Agenda Item 4
1124 Fairview Avenue
New Single-Family Residence on a Vacant Lot

1124 Fairview Avenue

Agenda Item 5
1206 Estate Lane
New Single-Family Residence on a Vacant Lot

1206 Estate Lane

1 FRONT ELEVATION
AR 03

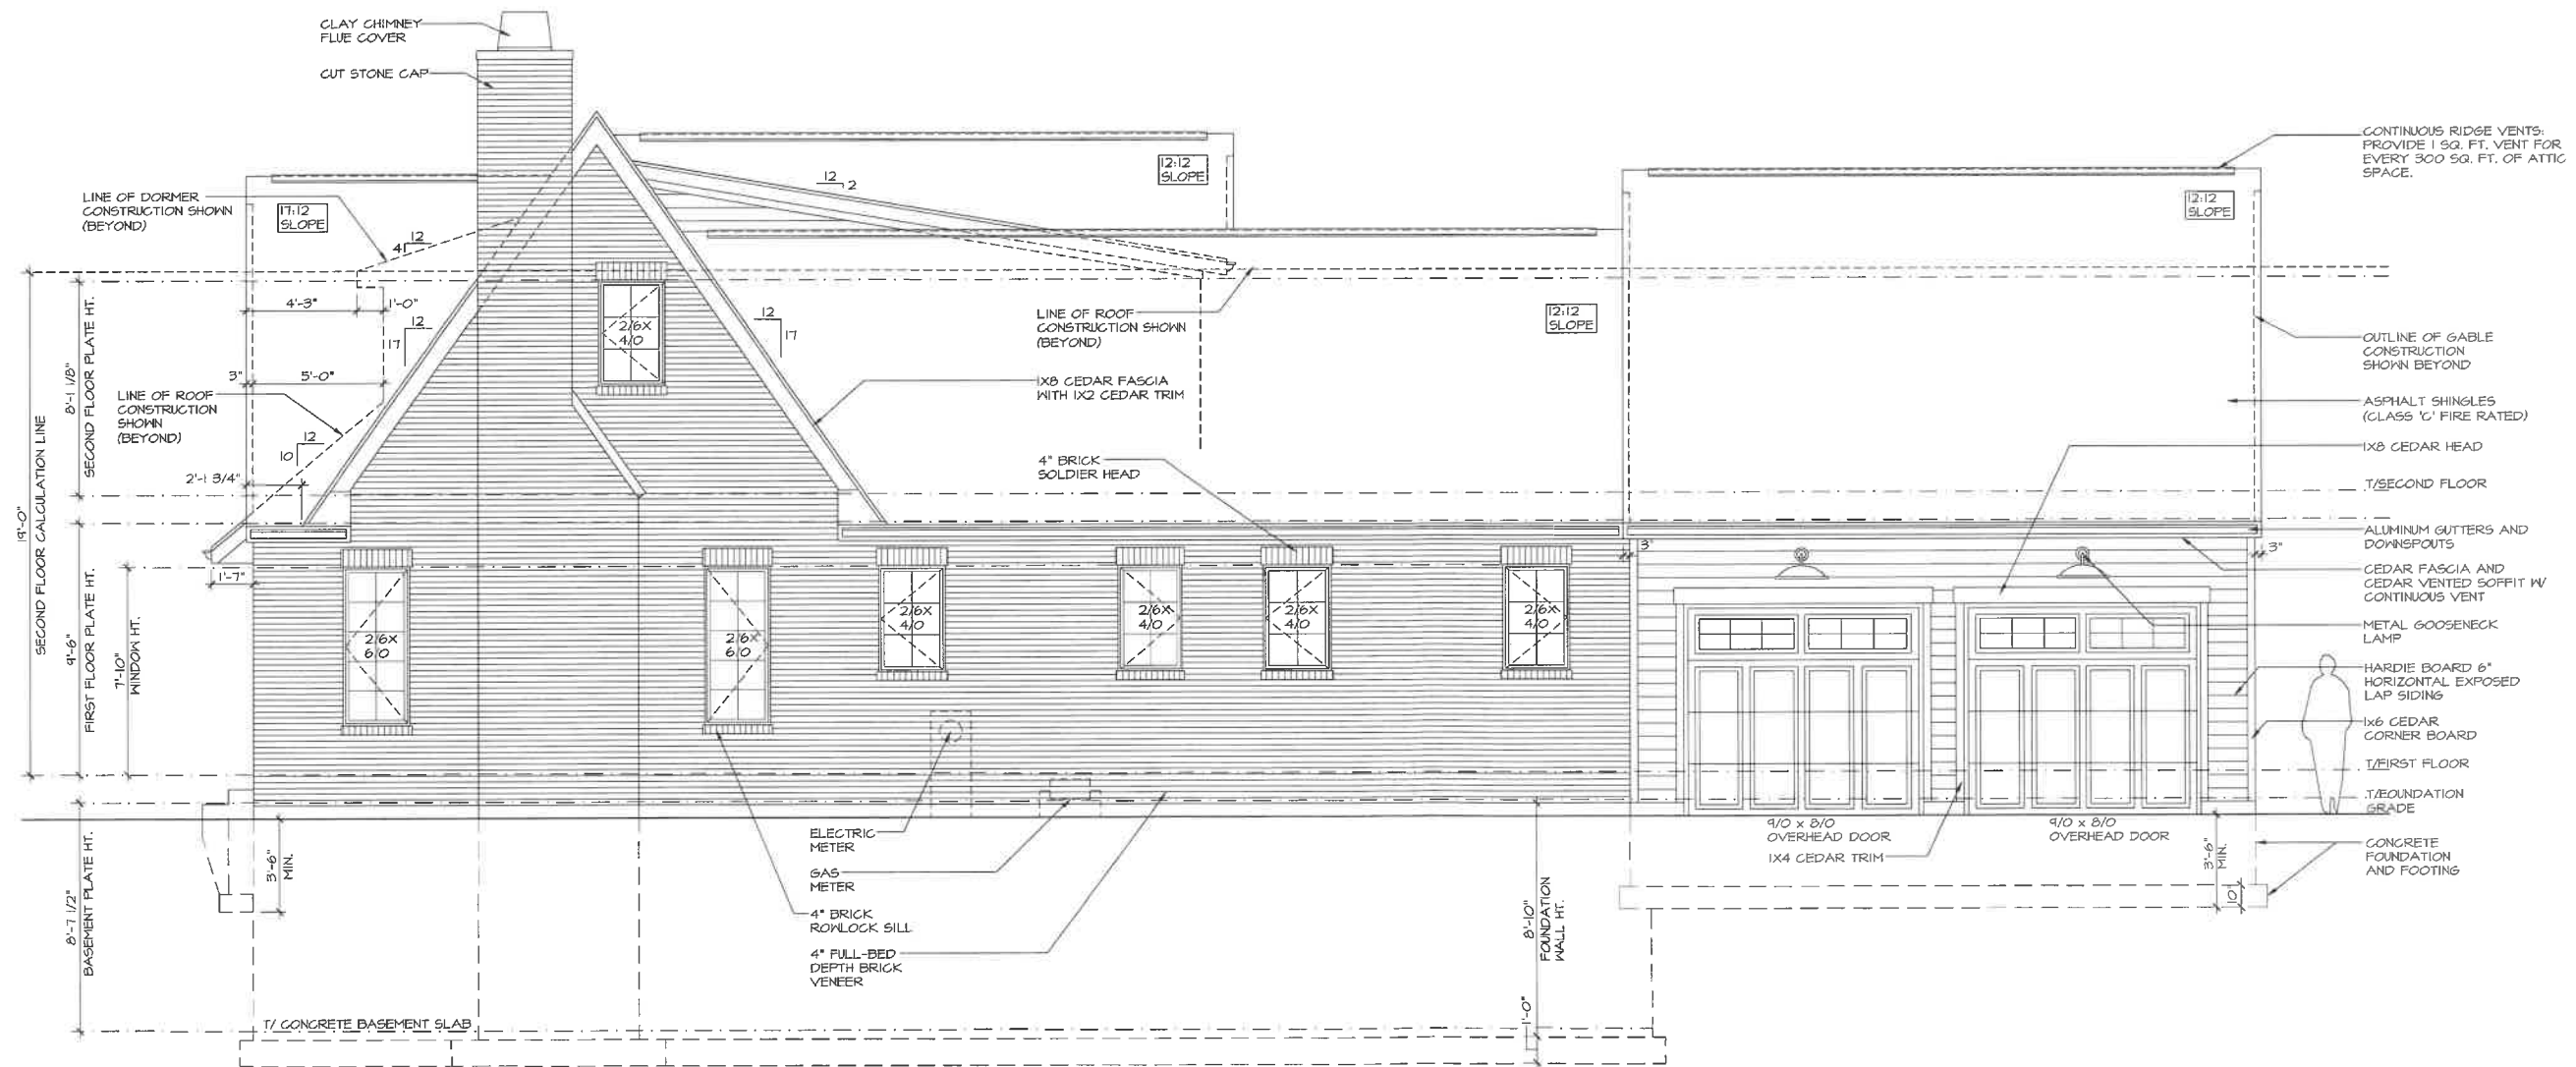
The east (front) elevation demonstrates the Cottage Style characteristics, including steep gables, an arched door, a small, covered entrance, and a prominent chimney. The characteristic gable roof is carried onto the north, west, and south elevations. Throughout the elevations, the relationship and organization of windows to solid walls is well balanced.

SITE PLAN

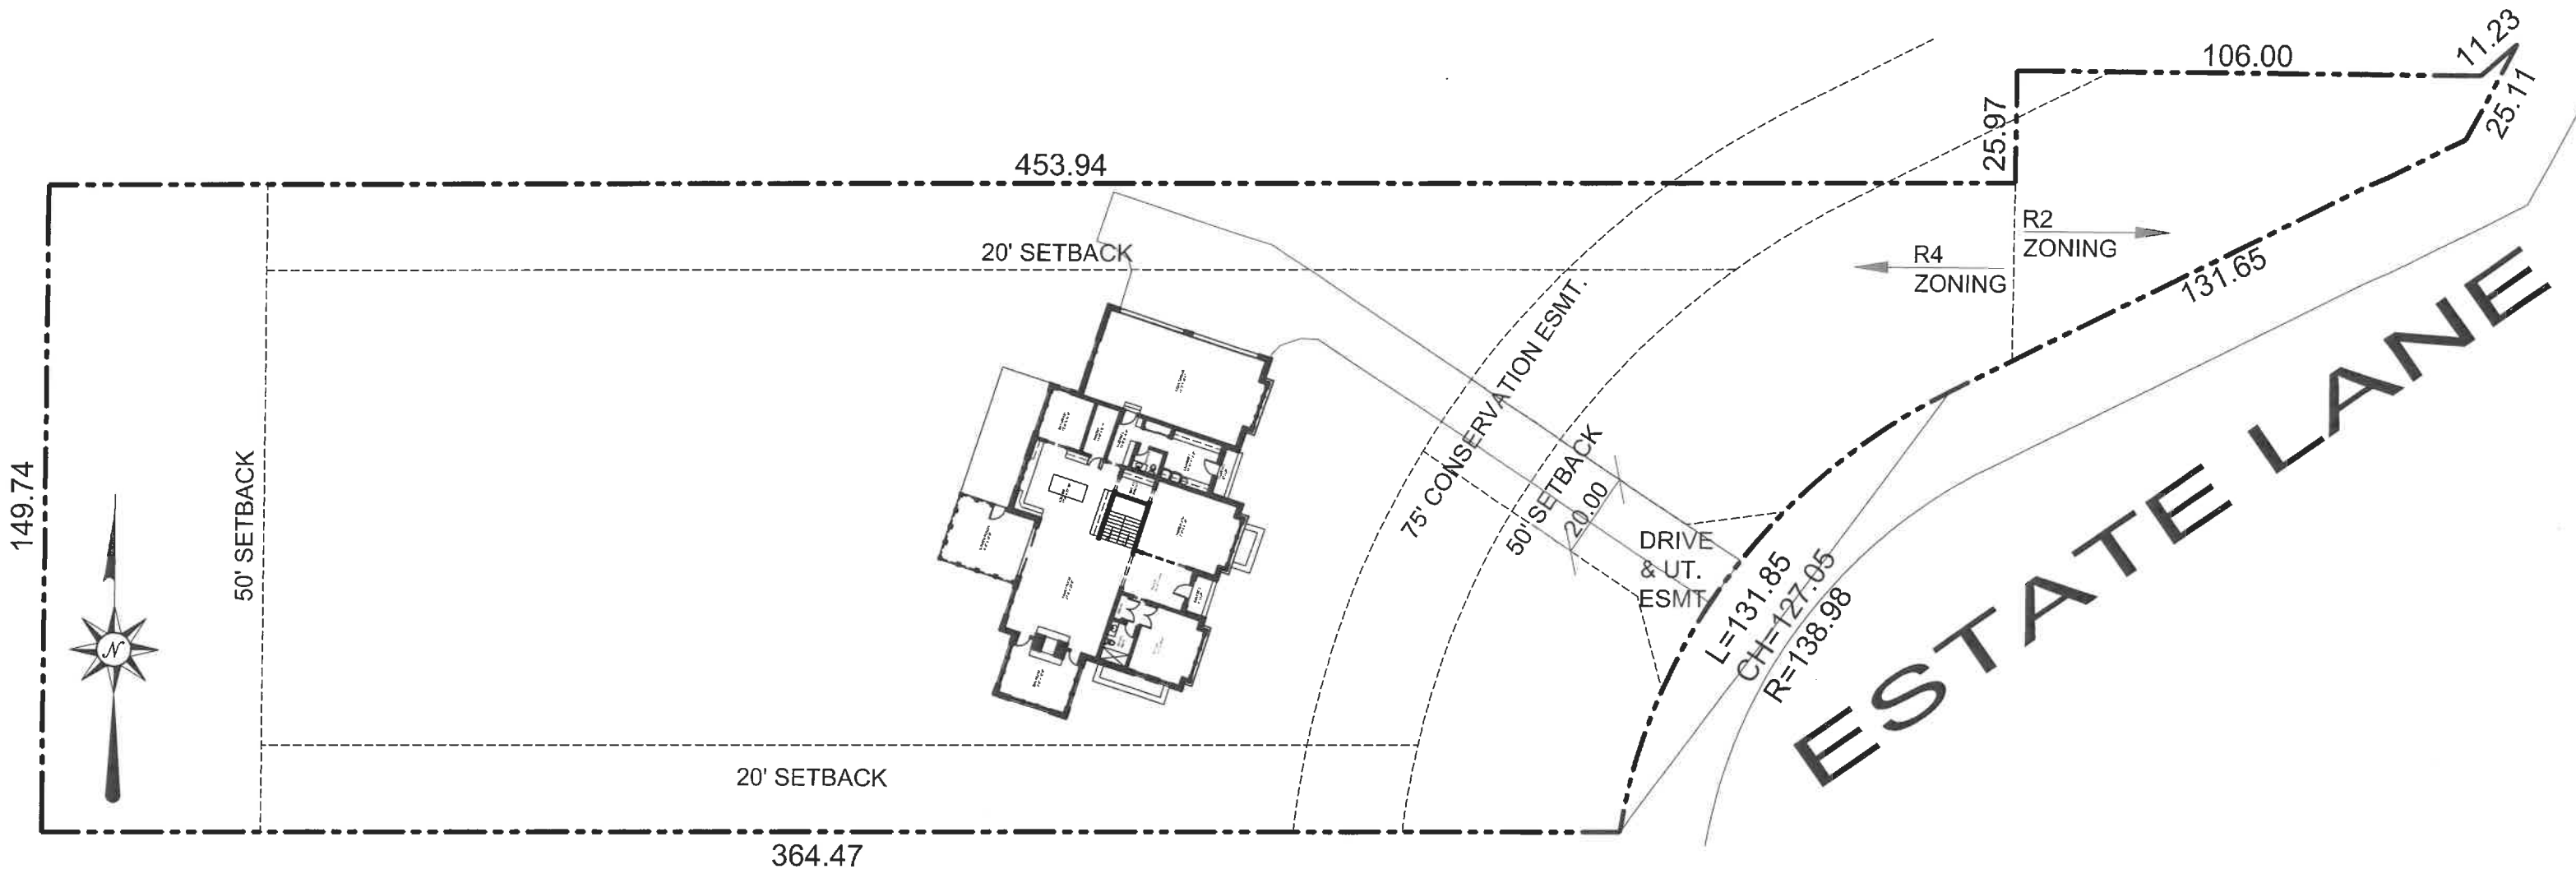
The house is generally centered north-to-south on the lot but positioned closer to the east property line, resulting in a large rear yard. The house faces east toward Estate

Lane. An asphalt driveway is proposed in the driveway easement leading to an apron and turn around area for a four-car garage. The edge of the apron appears close to the north property line. The siting of the home and driveway should be adjusted to provide proper space for drainage and the planting of vegetative screening between the driveway apron and the property line. The Lake County maps indicate the potential presence of wetlands on the property. Verification will be needed at the time of permit.

According to the landscape plan, a brick paver walkway from the driveway to the front entrances is proposed however, it does not appear on the site plan. The final site plan should show all proposed hardscaping.

Staff Recommendation: Adjust the siting of the home to create space between the garage apron and the property line to the north for drainage and vegetative screening.

Staff Recommendation: Show all proposed hardscaping on the site plan.

NORTH ELEVATION

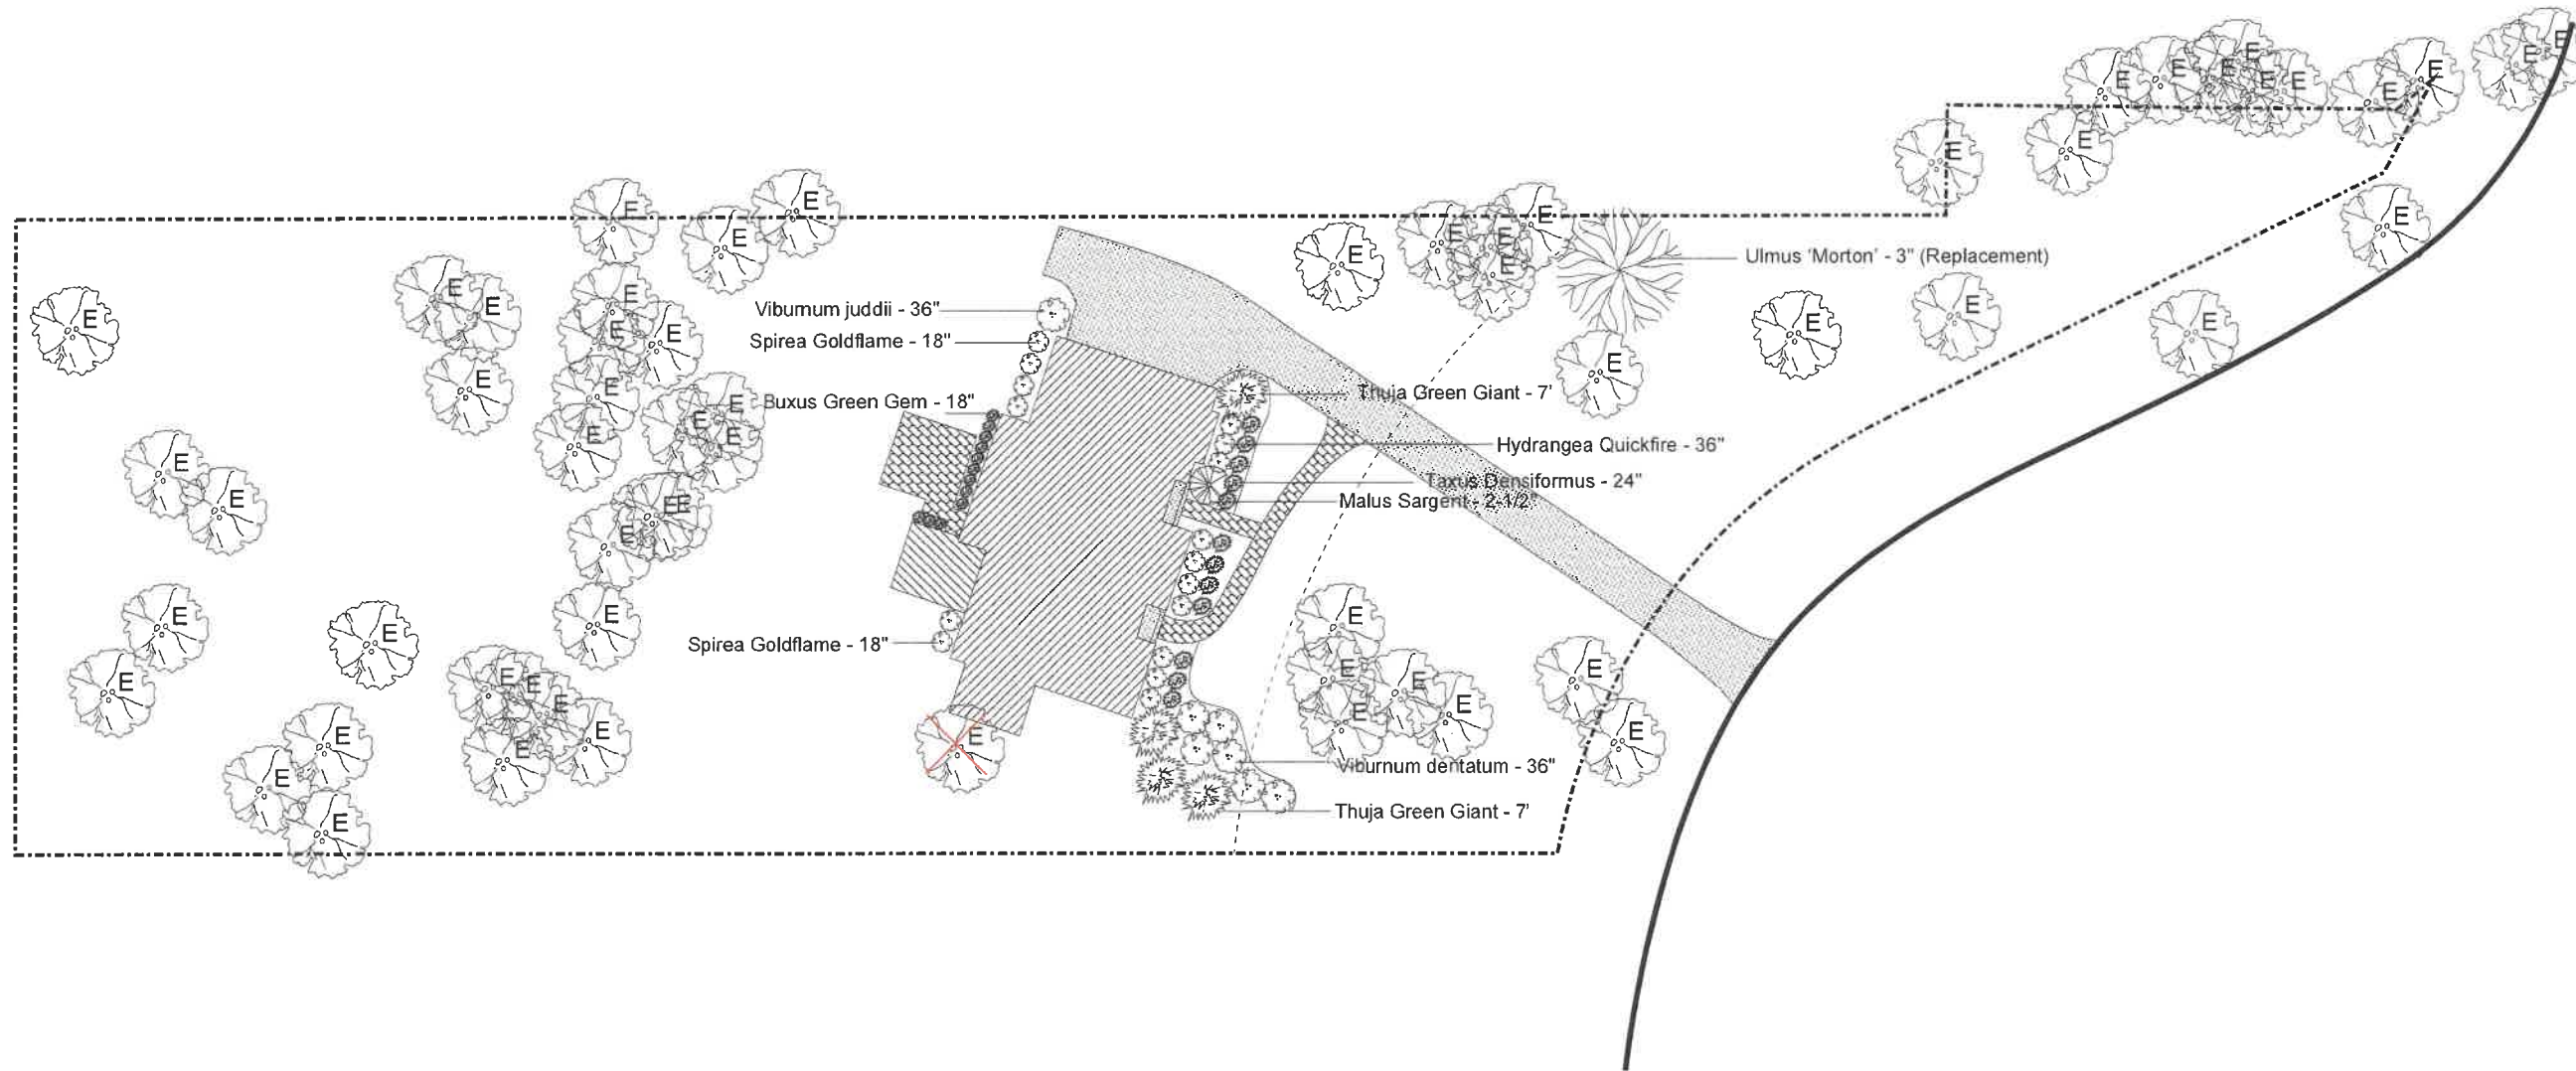
The Design Guidelines also emphasize the regular arrangement of openings and the balance of windows to solid walls. Across the elevations, there are numerous window shapes and sizes, including a mixed implementation of headers and sills. Studying and refining the elevations for consistency could better align the residence with the Guidelines. In particular, balancing the relationship of windows to solid wall massing on the south elevation should be considered.

Staff Recommendation: Simplify the massing and roof forms on the east and north elevations.
